Access Compliance Report

Public Rights-of-Way

(Curb Ramps)

Intersection ID: 48392	Main Street: ALVIN_WOODS_DR	Cross Street: JOE_MORRISON_LN	Location:	N
ADA ID: 392122117510	Ramp Type: BlendTrans1	Initial Pass/Fail: Fail	Overall Compliance: No	Severity Score: 21.25
Codes/Mitigation Info/Possible Solution		Field Measurements/Component Compliance

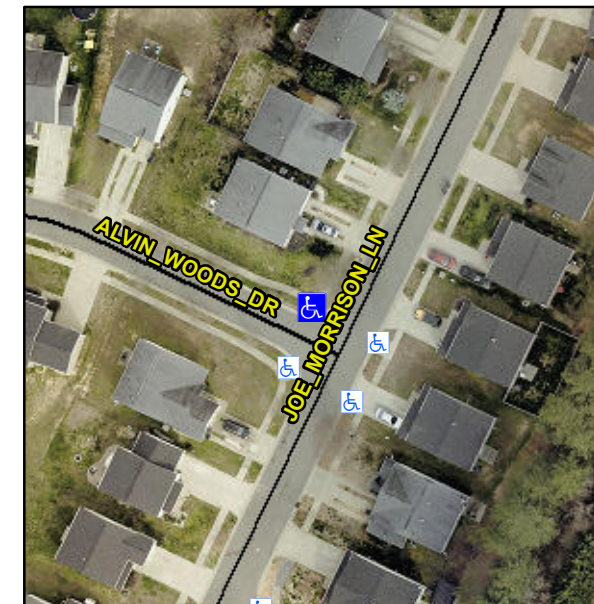
Not Found, R304.5.1, R304.5.3

Compliance	Description	Data	Compliance	Description	Data
N/A	Ramp Length (in)	72.0	Yes	BlendTrans Slope (%)	4.4
No	Ramp Width (in)	45.0	No	BlendTrans XSlope (%)	5.5
N/A	Flare Type LT	N/A	N/A	Flare Type RT	N/A
N/A	Flare Slope LT (%)	N/A	N/A	Flare Slope RT (%)	N/A
N/A	Flare Traversable LT?	N/A	N/A	Flare Traversable RT?	N/A
N/A	Landing Length (in)	N/A	N/A	DWS Provided?	N/A
N/A	Landing Width (in)	N/A	N/A	DWS Contrast?	N/A
N/A	Landing Slope (%)	N/A	N/A	DWS Length (in)	N/A
N/A	Landing X Slope (%)	N/A	N/A	DWS Full Width?	N/A
N/A	Landing Curb? (Y/N)	N/A	N/A	DWS Offset (in)	N/A
N/A	Shared Landing?	N/A			
N/A	Gutter Ponding?	N/A	N/A	Gutter Slope (%)	N/A
N/A	Gutter Lip Ht (in)	N/A	N/A	Gutter X Slope (%)	N/A
N/A	Painted X Walk1?	No	N/A	Painted X Walk2?	No
	X Walk 1 Direction	To SW		X Walk 2 Direction	To SE
	X Walk 1 Width (in)	N/A		X Walk 2 Width (in)	N/A
	X Walk 1 Slope (%)	1.4		X Walk 2 Slope (%)	4.7
	X Walk 1 X Slope (%)	6.2		X Walk 2 X Slope (%)	0.9

Remove & Replace Curb Ramp With Two New Directional Ramps or Equivalent.
